Diagnosis and Repair Bulletin

**Subject: Six-Cylinder Camshaft
Pin Breakage**

**Application: 1977-80 Jeep Vehicles
With Six-Cylinder Engines**

No. 80-3 Feb. 4, 1980

Fig. 1 Ammeter Circuit — Cherokee - Wagoneer - Truck Models

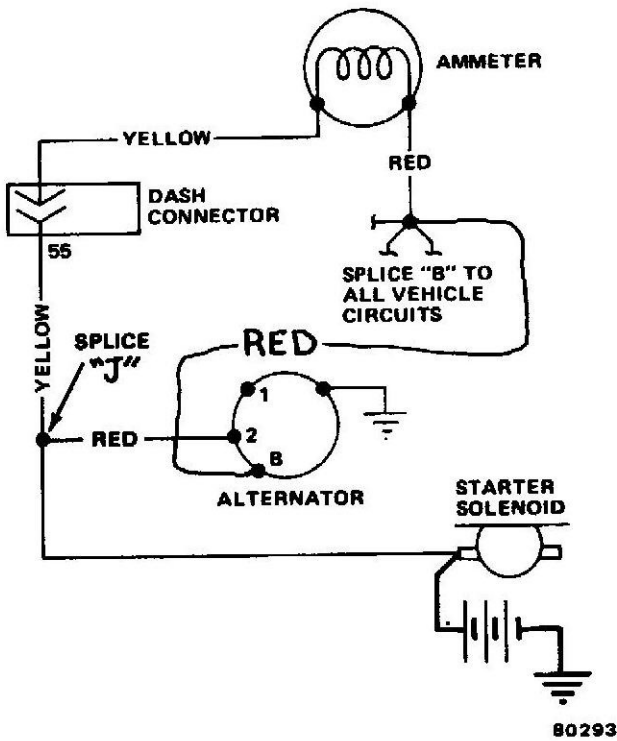
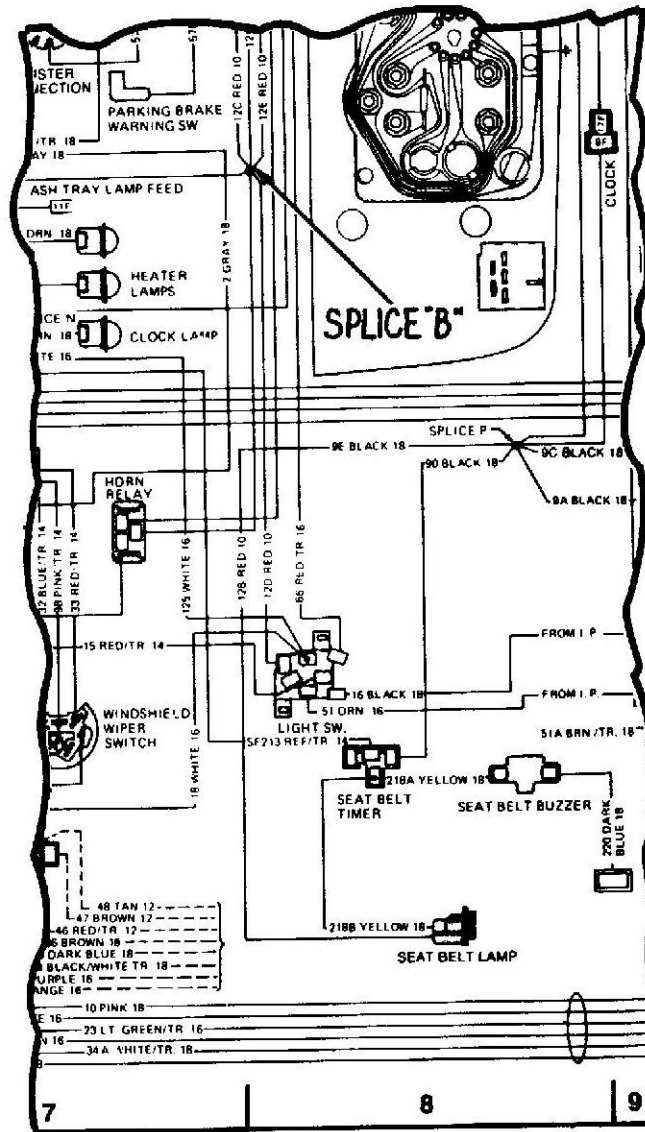
This bulletin is being issued to revise the ammeter circuit illustration for Cherokee, Wagoneer, and Truck models on page 1L-43, Volume I of the 1978 Technical Service Manual and on page 1L-45 of the 1979 Technical Service Manual. The revised circuit illustration is shown in figure 1. In addition, the wiring diagram for Cherokee, Wagoneer, and Truck models on page W-5 in the 1979 Technical Service Manual has also been revised to identify splice "B" as shown in figure 2.

Fig. 4

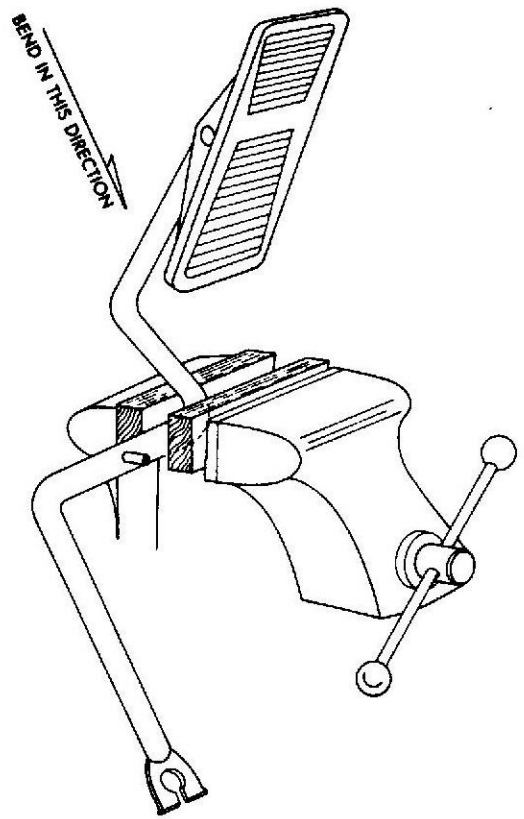
(7) Bend accelerator bellcrank as shown in figure 4, distance recorded in step (2).

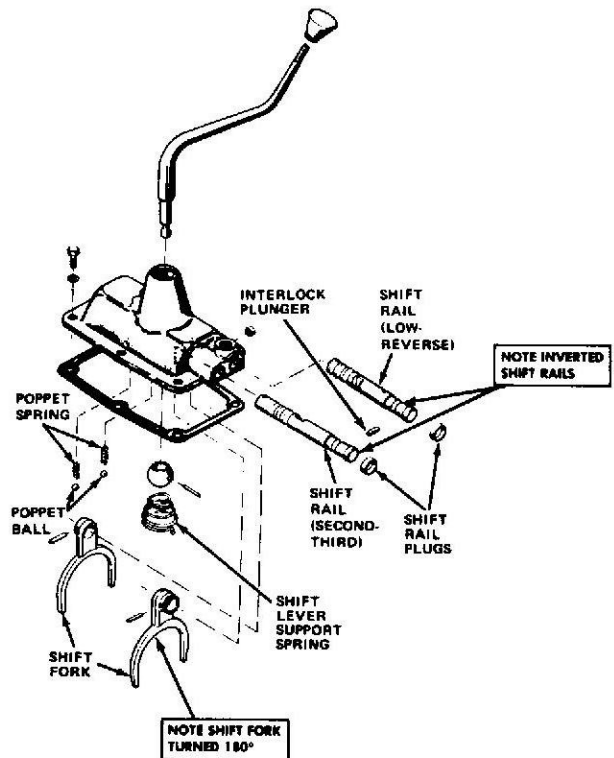
This bulletin is being issued to correct an error in the illustration of the shift control housing used on Model T-15A manual transmissions.

Fig. 1 Control Valve Assembly Spring

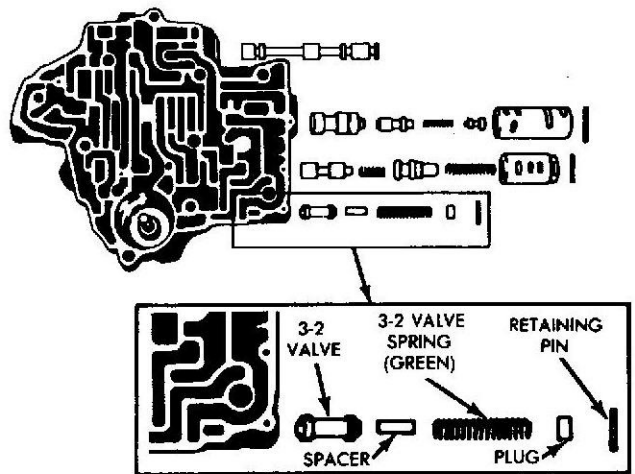
- (7) Install spacer, new 3-2 spring (green), bore plug, and retaining pin (Fig. 1).

Fig. 1 Indexing Gear Housing

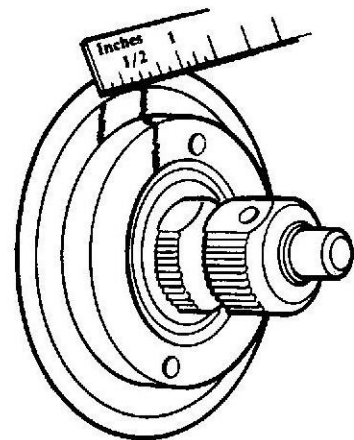
C. On page 11-58 under the subtitle "WORMSHAFT BEARING PRELOAD," step (3) should be changed to read: Measure counterclockwise one-half inch (13mm) from first index mark and remark housing. Refer to Figure 1 below.

Fig. 2 Revised Steering Gear Leak Diagnosis and Corrective Action (View A)

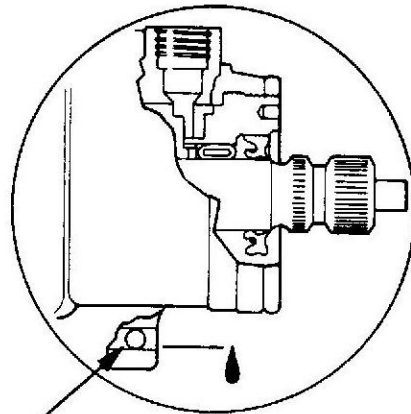
B. On page 2L-12, figure 2L-7, View A, the information referring to the ball plug should read as shown in fig. 2.
